November 1, 2007
E-25747

Subject: Application for Amendment 1 of the NUHOMS® HD Certificate of Compliance
No. 1030 for Spent Fuel Storage Casks, Revision 0

Figure 4-34
Temperature Distribution for TC Backfill Operations

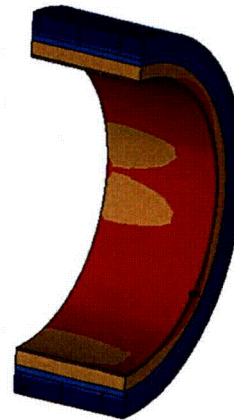
Section #	Page #	Reason for Change
Figure 4-34	1 page	Clarify figure title, Temperatures for TC backfill operations
Figure 4-35	1 page	Figure Deleted
Figure 4-36	1 page	Figure Deleted
Figure 4-37	1 page	Clarify figure title, Time-Temp. History for TC backfill operations
		Appendix 4.16.3
	1 page	New Appendix to discuss the addition of CE 16x16 Fuel
		Appendix 4.16.4
	1 page	New Appendix to discuss reduction in ambient temperature to -21 °F
		Chapter 5

The maximum fuel cladding temperatures during TC backfill operations are summarized in Table 4-8. Typical temperature distributions at the end of vacuum drying process are shown in Figure 4-34. Histories of the maximum component temperatures are shown in Figure 4-37.

Figure 4-37
Time-Temperature History for TC Backfill Operations

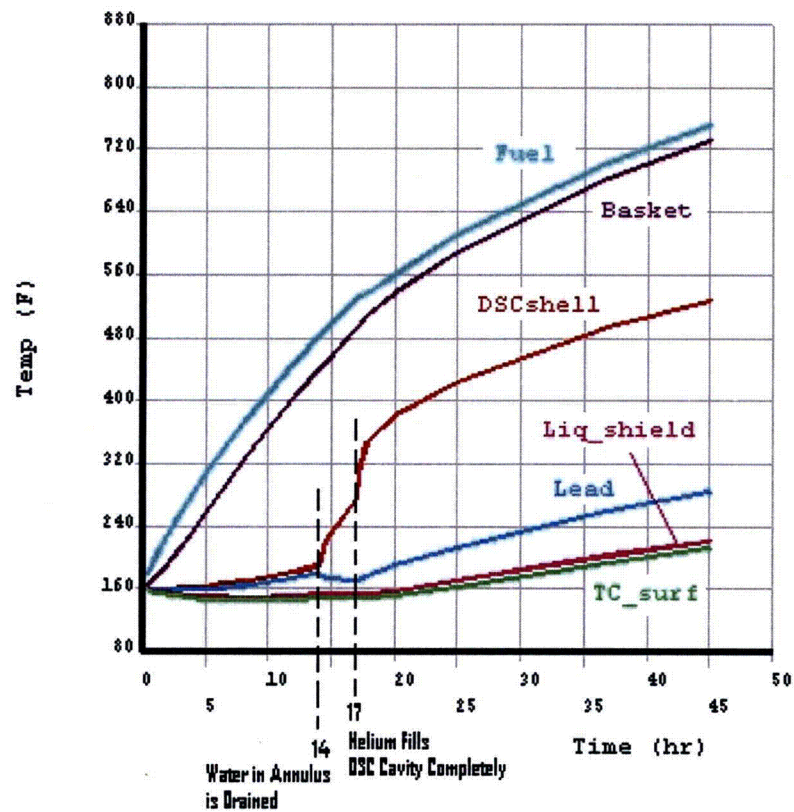
The time limit to start backfilling of the transfer cask with helium must be within 28 hours after drainage of the annulus water based on the time-temperature history curve shown in Figure 4-37.

Figure 4.16.3-1

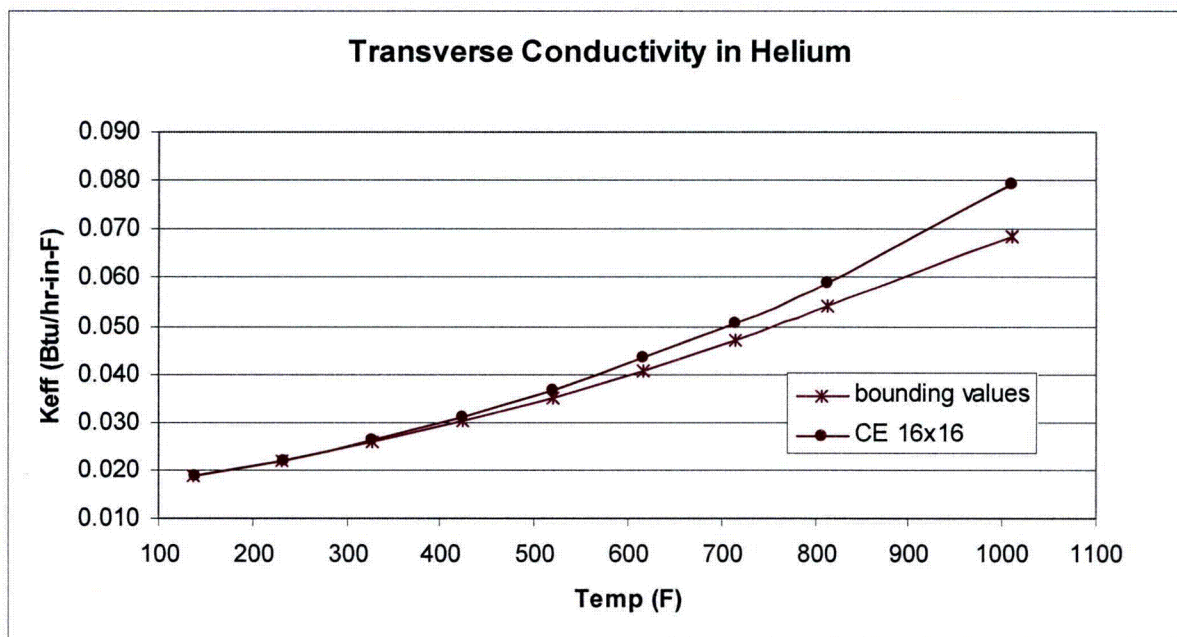
The effective transverse conductivity of fuel assemblies are plotted in Figure 4.16.3-1, which includes CE 16x16 fuel. The bounding values shown herein correspond to those from Chapter 4, Figure 4-41.

Figure 6-20
CE 16x16 Class Assembly – Optimum Pitch KENO Model with BPRAs

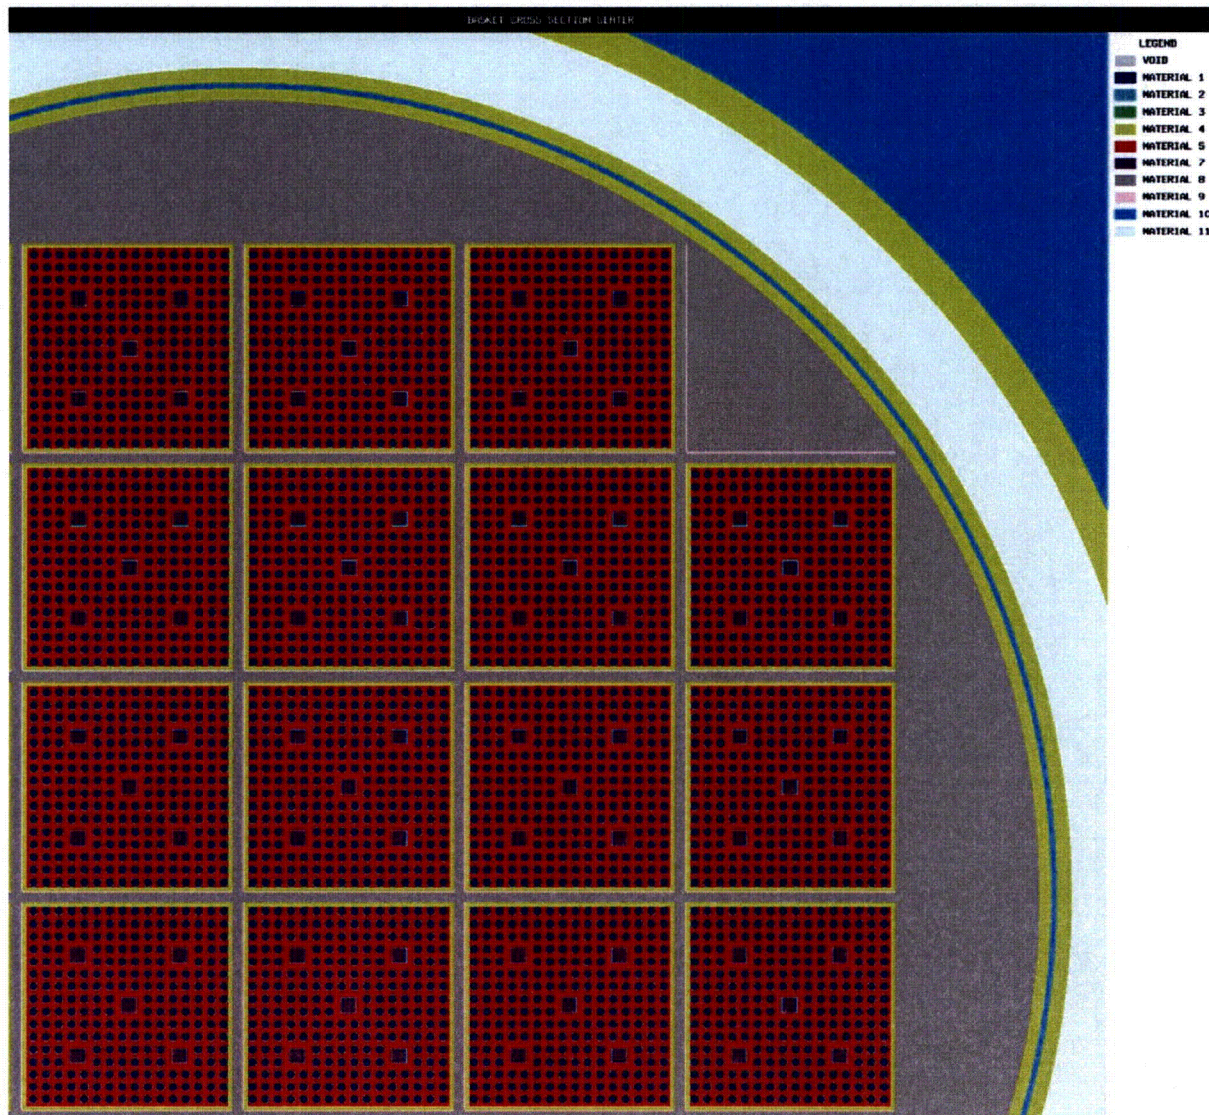
Table 6-36	4 pages	New Table for CE 16x16 results
Table 6-37	3 pages	Data from Old Table 6-34
Table 6-38	4 pages	New Table for CE 14x14 results
Table 6-39	4 pages	New Table for CE 16x16 results
Table 6-40	4 pages	New Table for CE 16x16 results
Figure 6-14	1 page	Modified to show CE 14x14 model
Figure 6-20	1 page	New Figure for CE 16x16 models with BPRA
Chapter 8

due to the presence of soluble boron in the moderator. The removal fuel rods would ensure that the fissile fuel rods are replaced with boron poison and would result in a reduction in k_{eff} . Therefore, the rod pitch study is completed by determining the optimum pitch and the associated maximum k_{eff} at optimum moderator density. The 2D KENO plot for the CE 14x14 fuel assembly (without BPRAs) is shown in Figure 6-14. The 2D KENO plot for the CE 16x16 fuel assembly (with BPRAs) is shown in Figure 6-20.
